Response to Cork County Council Pre-Application Consultation Opinion

For Development at Courtstown (townland), Little Island, Co. Cork

on behalf of Ruden Homes Ltd.

July 2024

Figure 1: Extent of Applicant's ownership

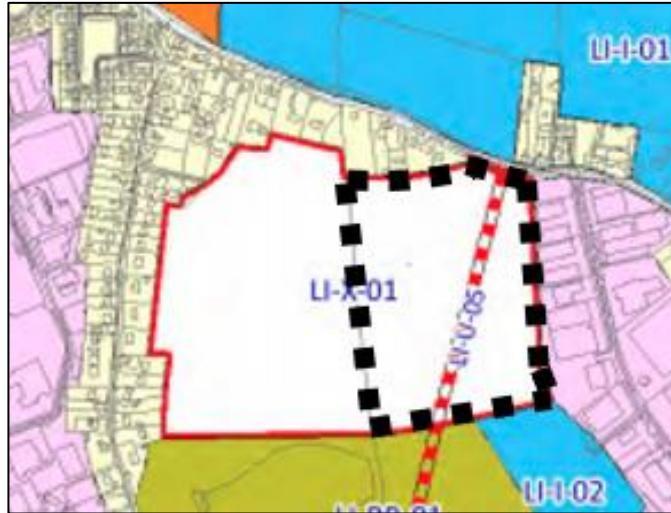
- 1. The zoning objective requires that the development of the overall LI-X-01 lands be subject to an approved framework plan for its overall development. Further consideration is required regarding the development potential of all LI-X-01 lands. This is particularly important in relation to transport impacts and in the context of the neighbourhood centre required by the zoning objective, and the stated vision “that development be integrated into the surrounding land uses, to ensure appropriate protection of the adjoining residential land use and to ensure an appropriate landscaping buffer between new residential development and adjoining industrial uses to the east” (s. 2.6.50).***

It is important to note that the designated X-01 lands consist of two parcels of land which are within different ownerships. Figure 1 shows the extent of the X-01 lands that are within our client’s ownership (indicatively demarcated by dashed black line). The land to the west is within separate ownership.
